RE: **Carothers Crossing East Subdivision (currently Duke Properties Subdivision) preliminary plat – COF
Project # 6005**
KVD Project No.: 15058

RE: **Carothers Crossing East Subdivision (currently Duke Properties Subdivision) preliminary plat – COF Project # 6005**
KVD Project No.: 15058

Below you will find an outline of our responses to the City of Franklin comments, dated 12/29/15, for the Carothers Crossing East Subdivision (currently Duke Properties Subdivision) preliminary plat submittal.

CAROTHERS CROSSING EAST
 (DUKE PROPERTIES SUBDIVISION, REVISION 1)
 PRELIMINARY PLAT SUBMITTAL - COF# 6005
 PRELIMINARY PLAT
 Franklin, Williamson Co, TN

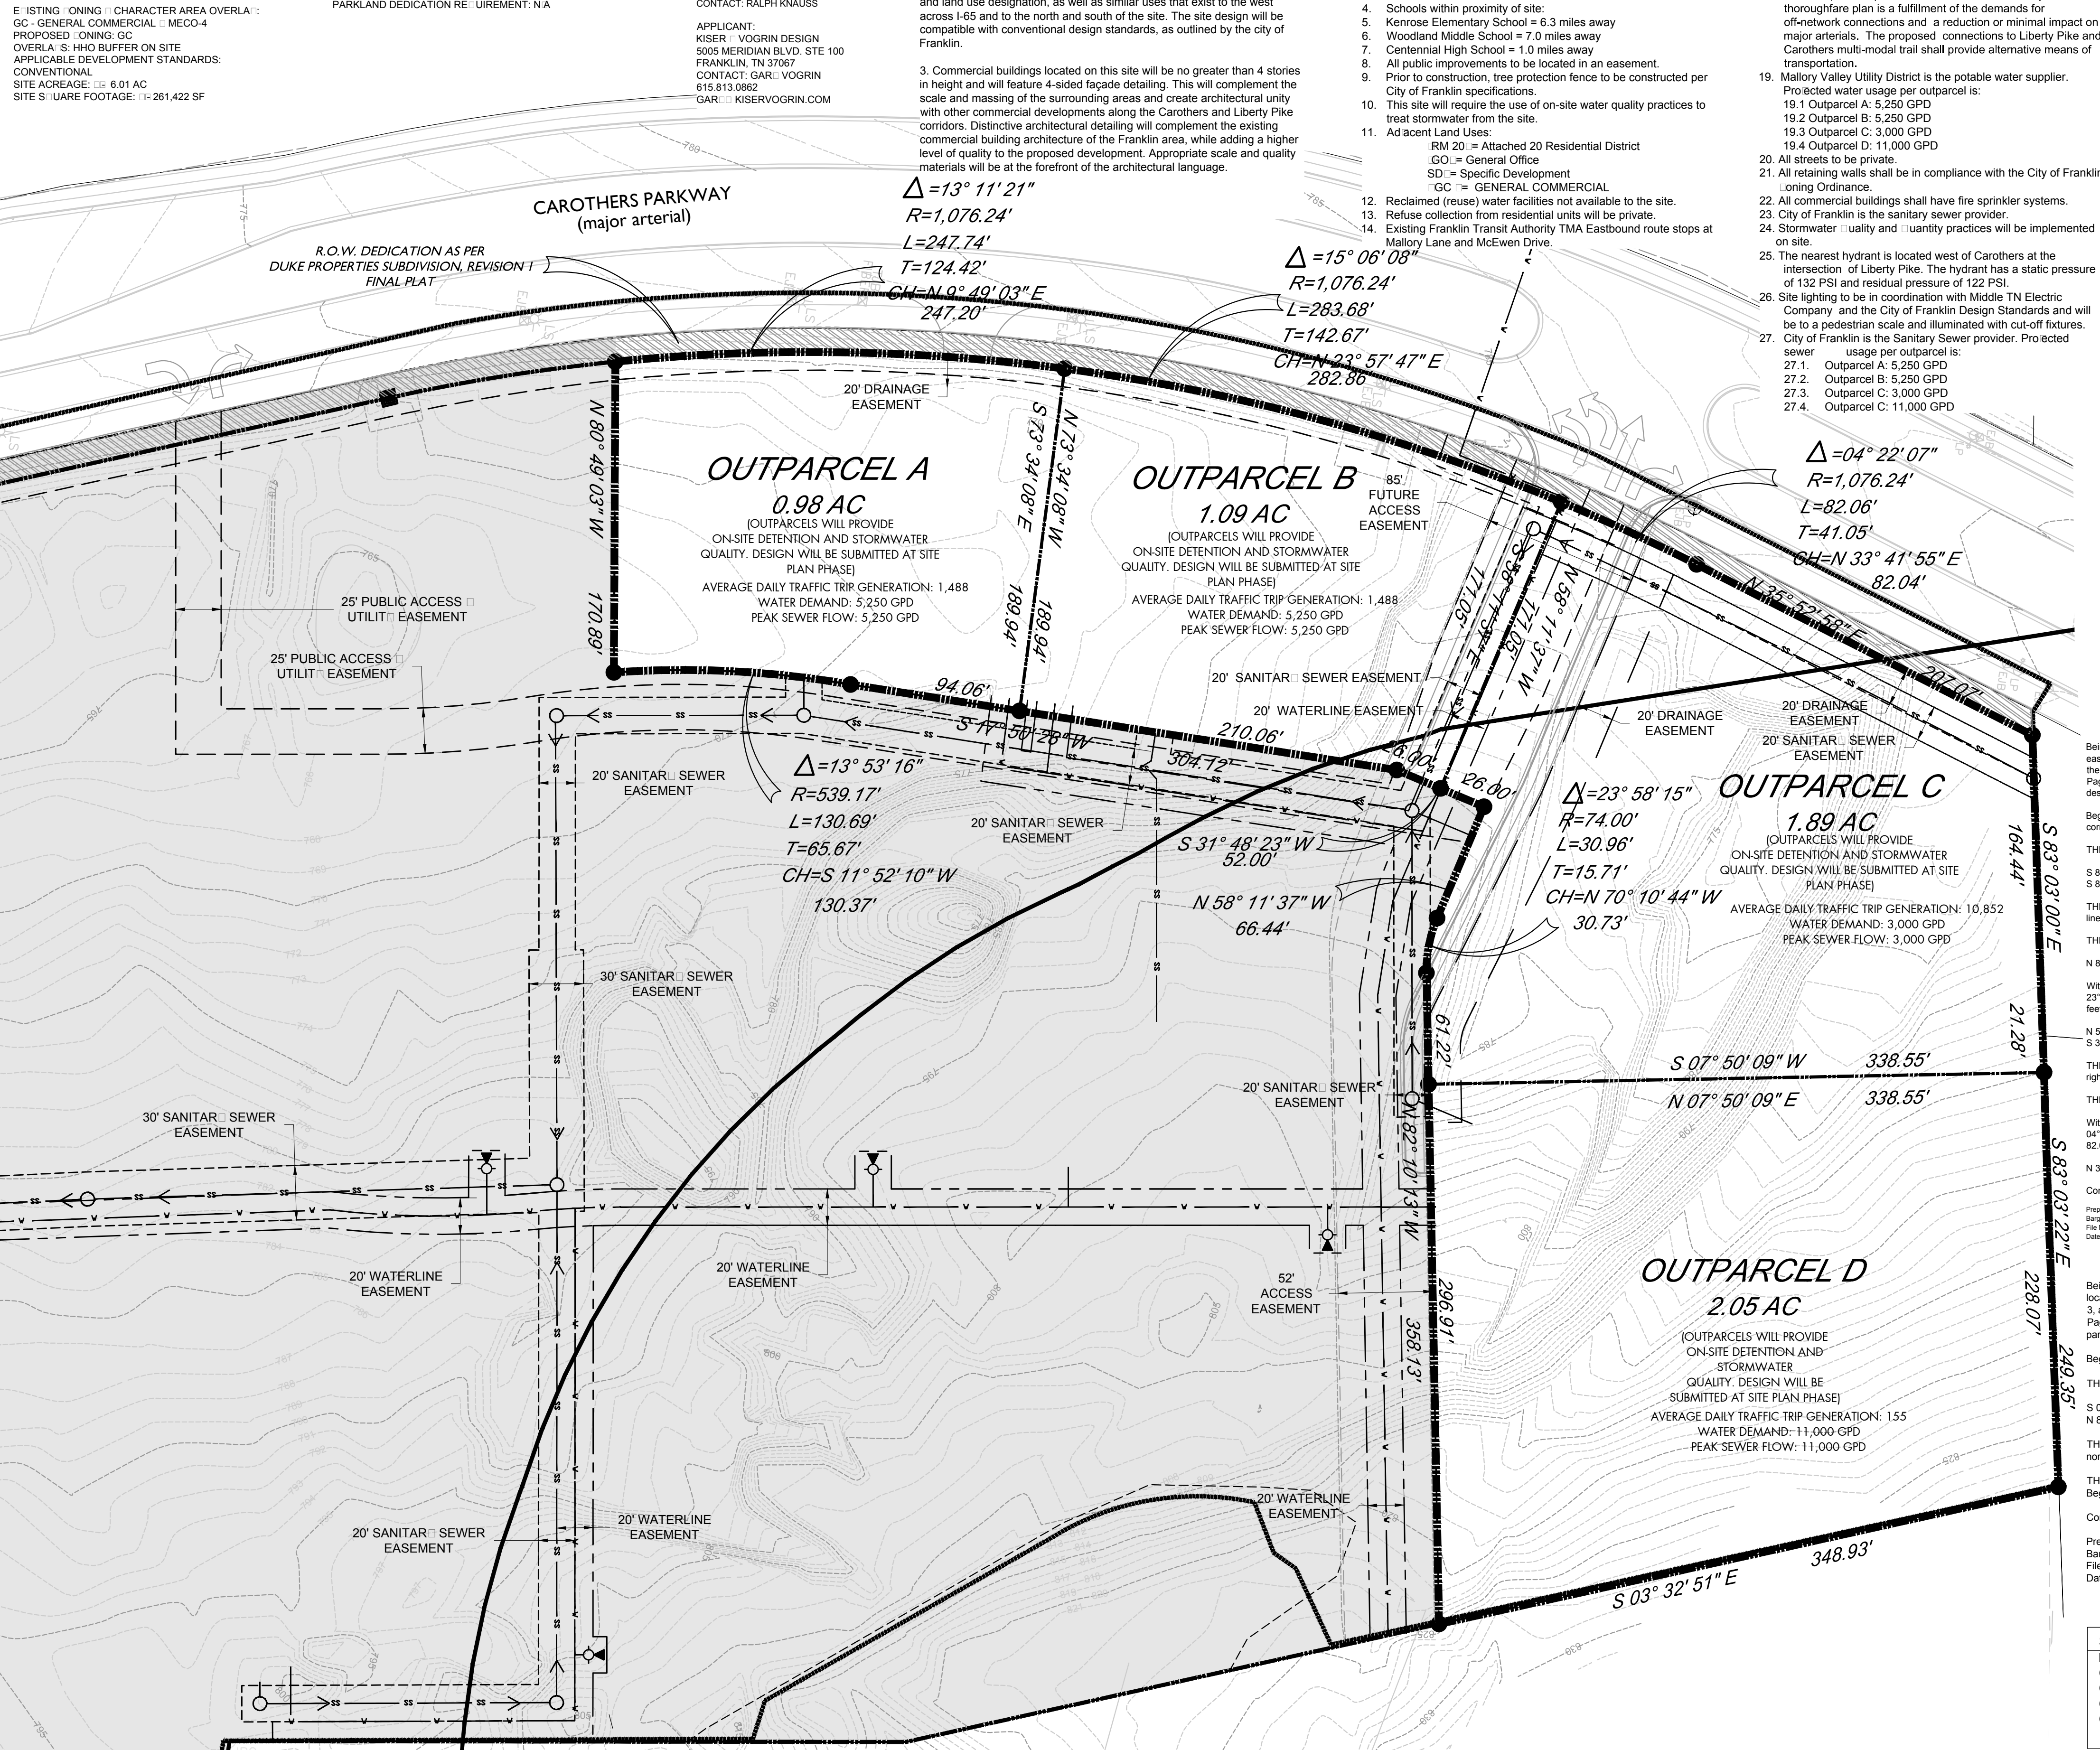
The sewer line and easement must cross Liberty Pike perpendicular to the right-of-way and perpendicular to the existing water line easements that are located adjacent and parallel to Liberty Pike. The sewer line location provided on this submittal may not have adequate depth to serve "Outparcel A". An additional sewer line may be required to provide sewer service to "Outparcel A".

The proposed sanitary sewer crossing alignment was addressed during the review process for the Carothers Crossing East Final Plat (COF #5978) and heard at the 12/17/15 FMPC as a condition of approval. We will incorporate the revised alignment on this preliminary plat. Approximate invert elevation of the manhole to the east of "Outparcel A" is 778 and the approximate mass grade elevation for "Outparcel A" is 785. We do not anticipate that an additional sewer line will be required to service "Outparcel A".

The previous comment "Applicant shall comply with Section 3.2.4 of the Street Specs. All development adjoining existing Arterial or Collector roadway are required to dedicate (fee simple) right-of-way to meet the minimum requirements for the functional street classification of the existing street." was not completely addressed. Additional right-of-way is required along Liberty Pike for improvements.

The proposed right-of-way dedication was addressed during the review process for the Carothers Crossing East PUD Development Plan (COF #5977) and the Carothers Crossing East Final Plat (COF #5978) and heard at the 12/17/15 FMPC as a condition of approval. We will incorporate the revised Liberty Pike right-of-way dedication on this preliminary plat.
